PROJECT: WALDEN CORPORATION WWTP
 3155 WALKER ROAD COLORADO SPRINGS
 EL PASO COUNTY, COLORADO
 ENGINEER: AQUAWORKS DBO, INC.
 3252 WILLIAMS STREET
 DENVER, COLORADO 80205
 (303) 477-5915

SHEET TITLE:
 LAGOONS CLOSURE PLAN
 PROJECT NUMBER: #3774
 SCALE: 1"=100'
 SHEET: C10

V3_ Pond reclamation.pdf Markup Summary

EPC Stormwater- Zachary (3)

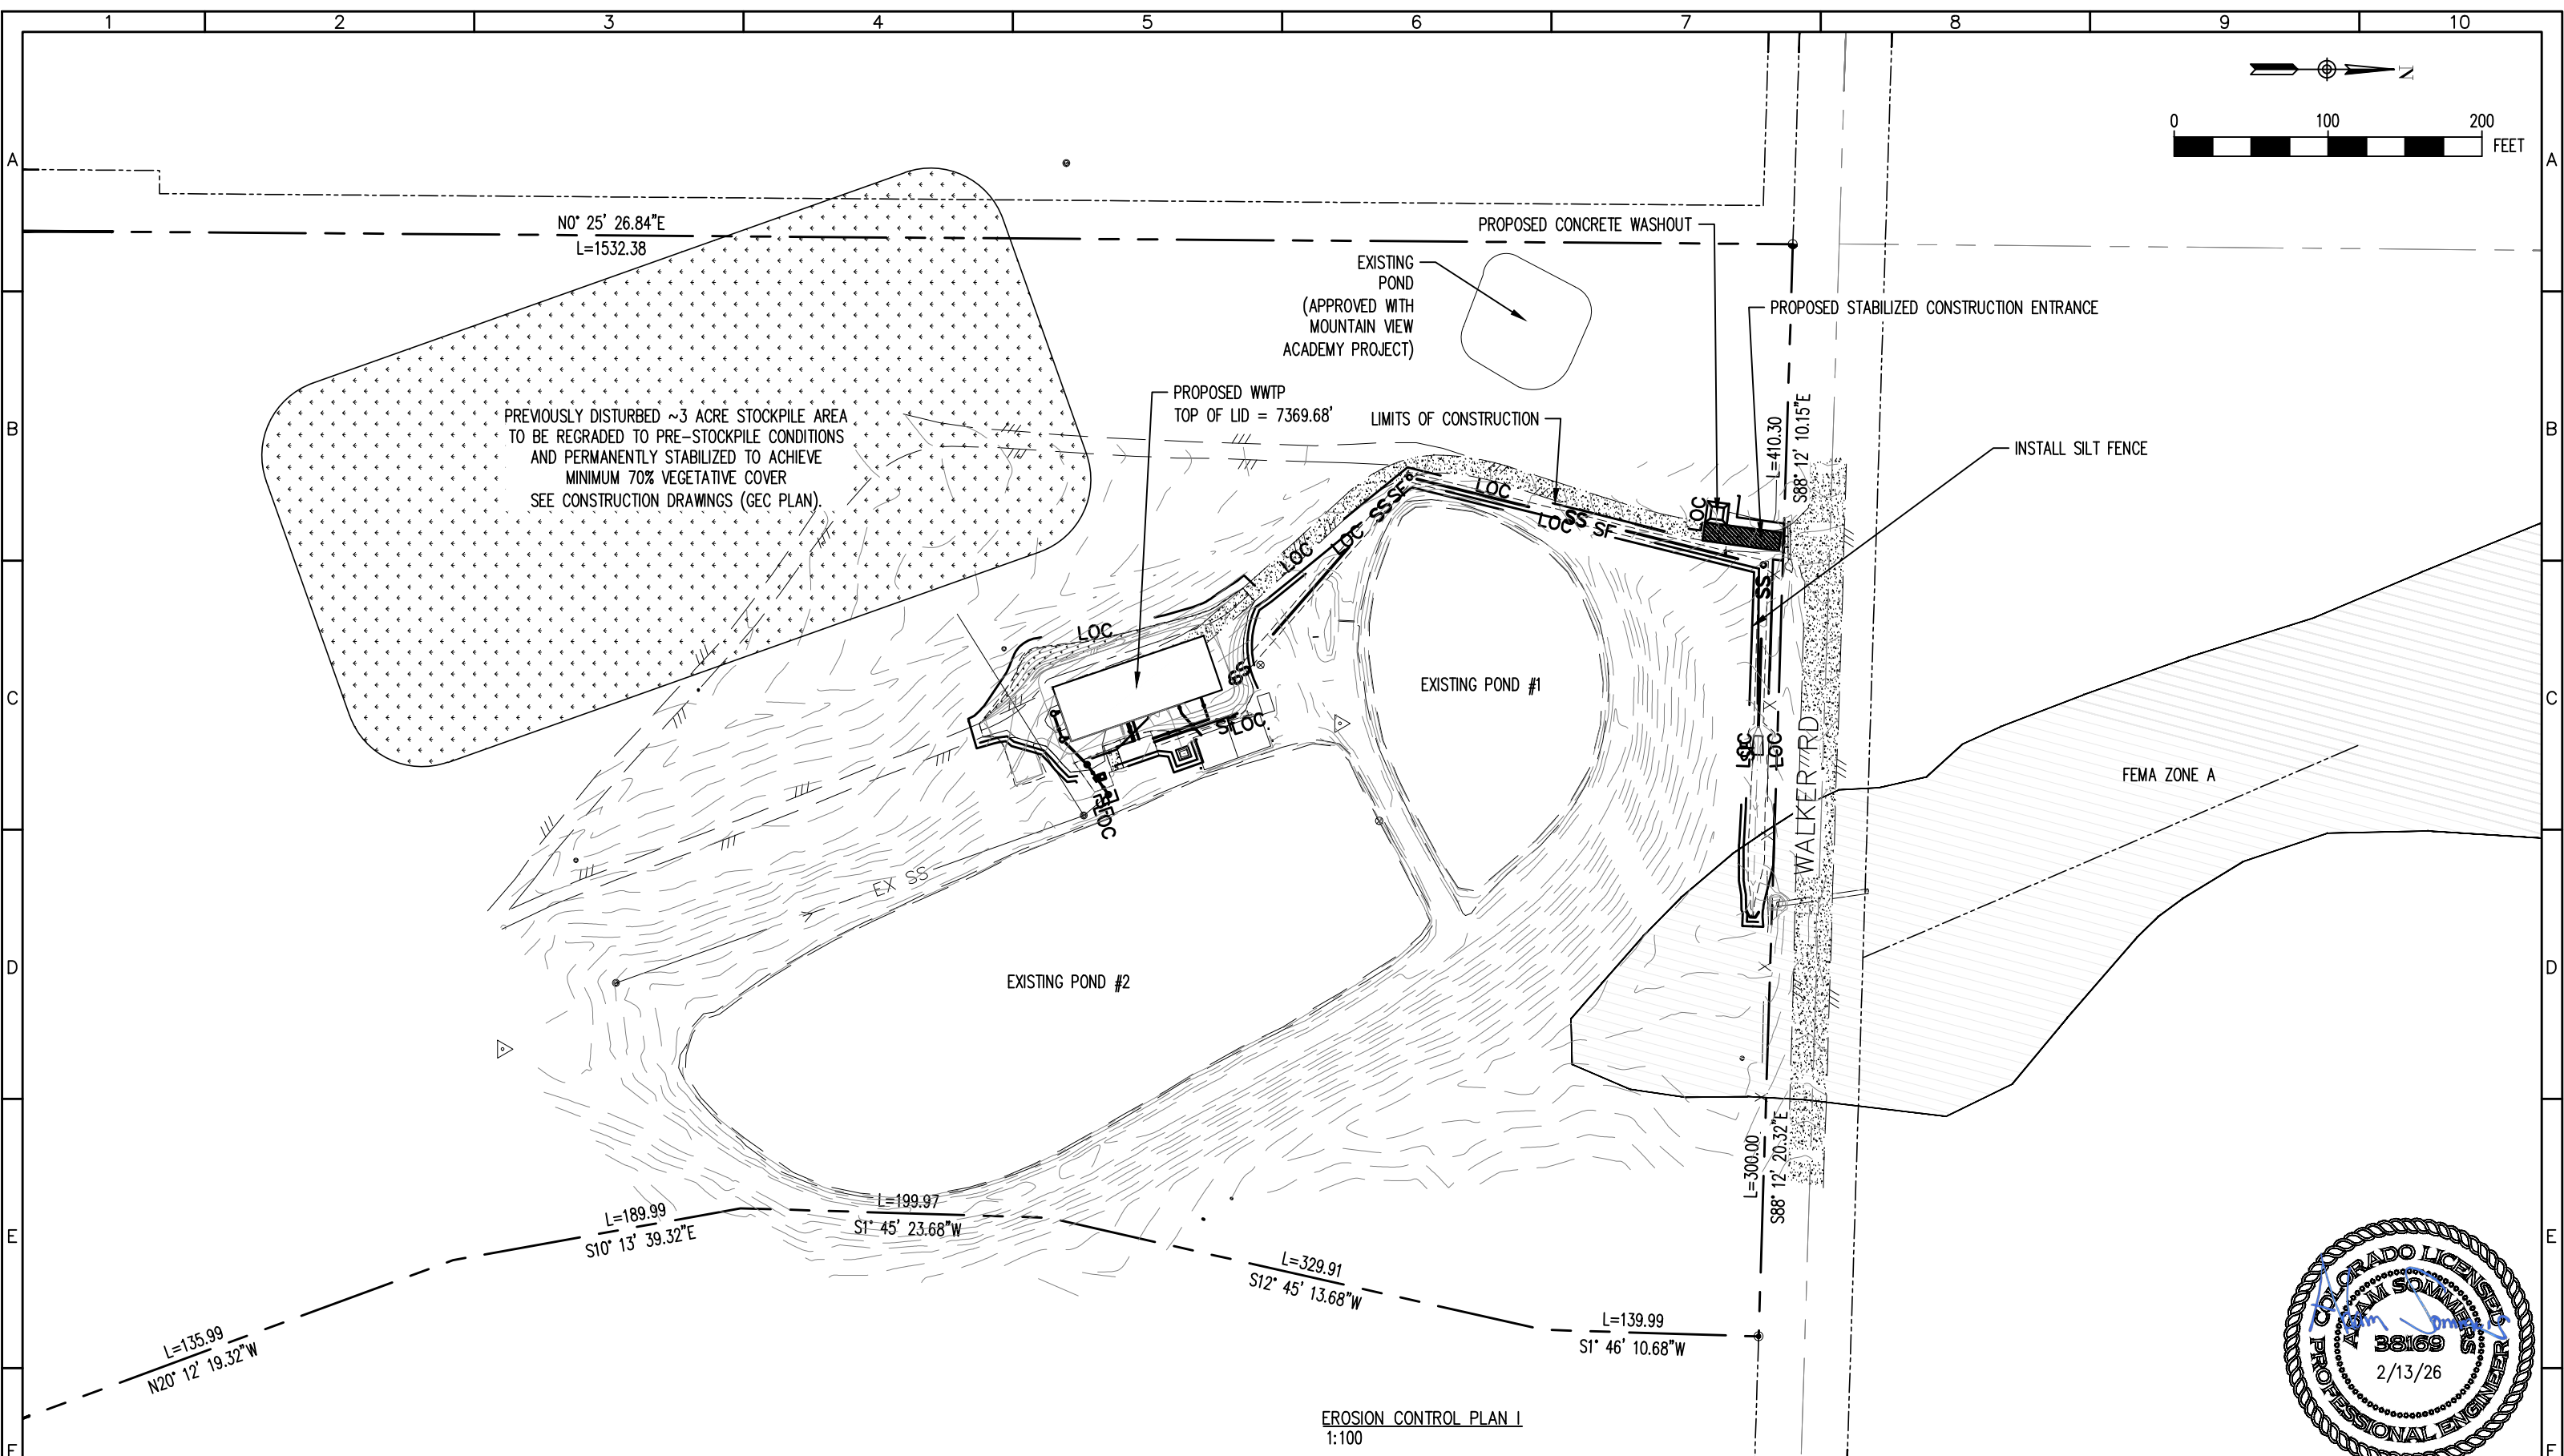
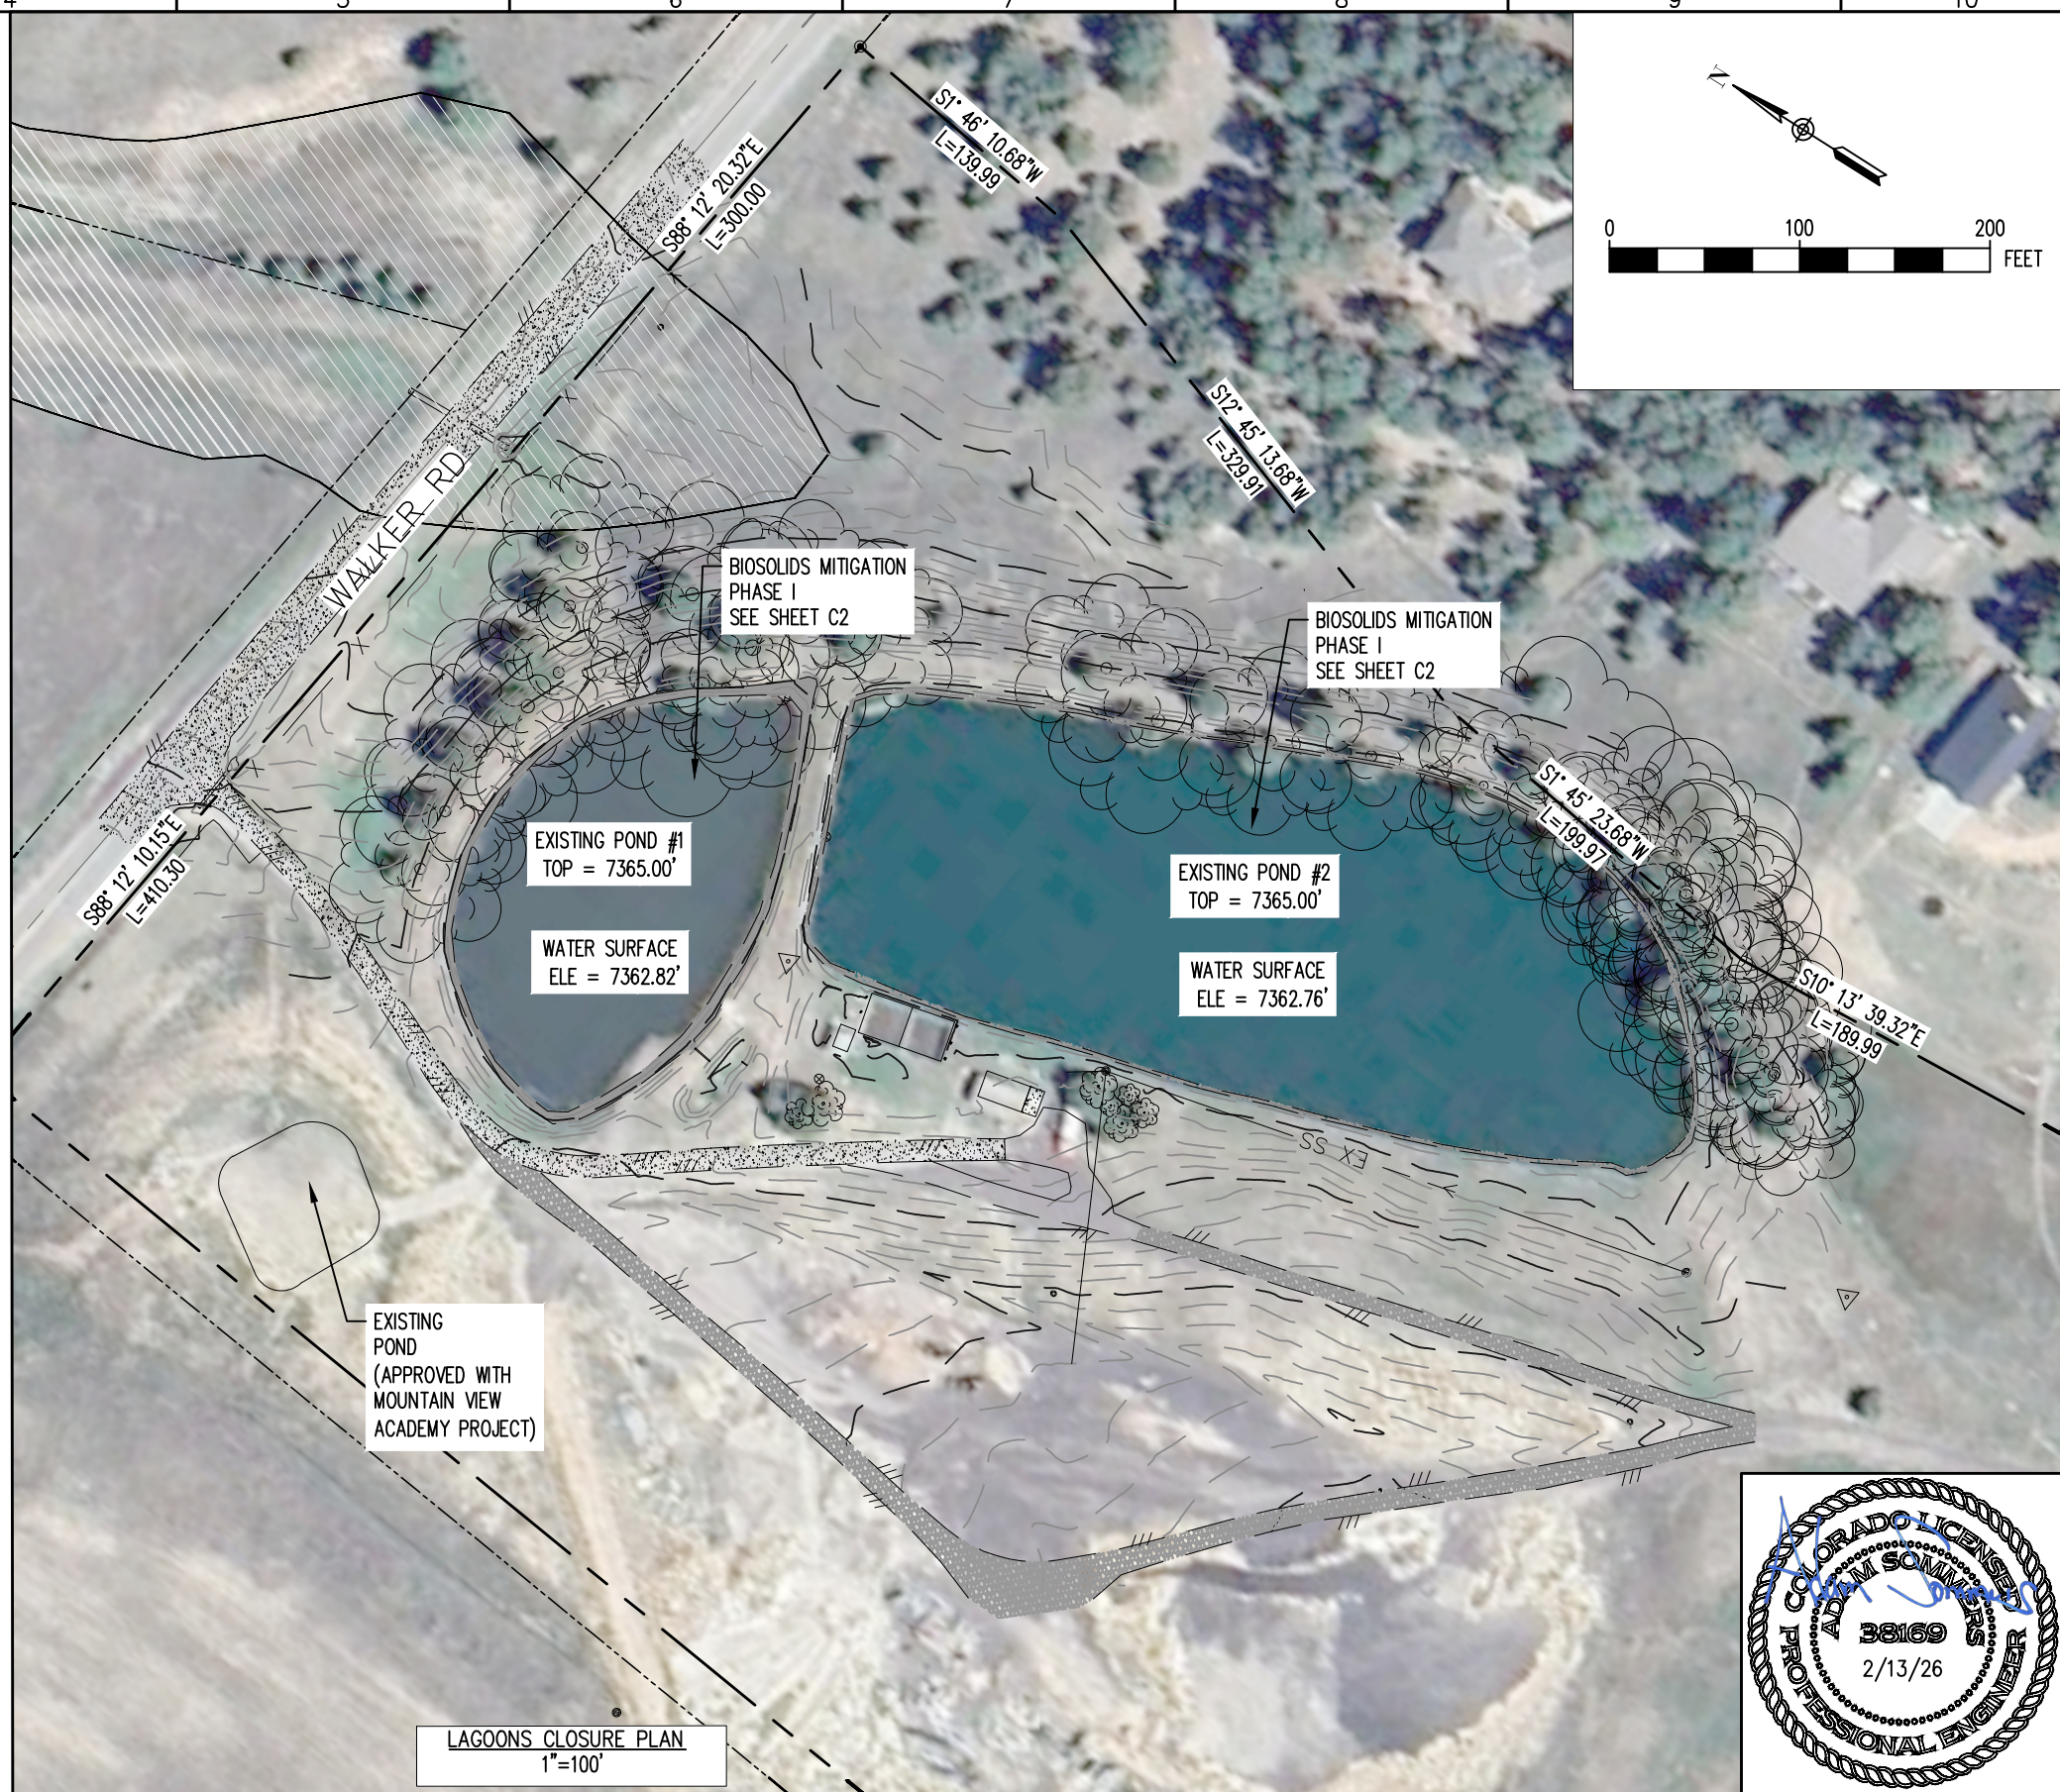
Show the anticipated dewatering operation on GEC plan and provide details.

See note on GEC plan. Reclamation plan must match GEC plan.

Please include a sheet of the pond in its final reclaimed state, including vegetation, pipes, and grading,
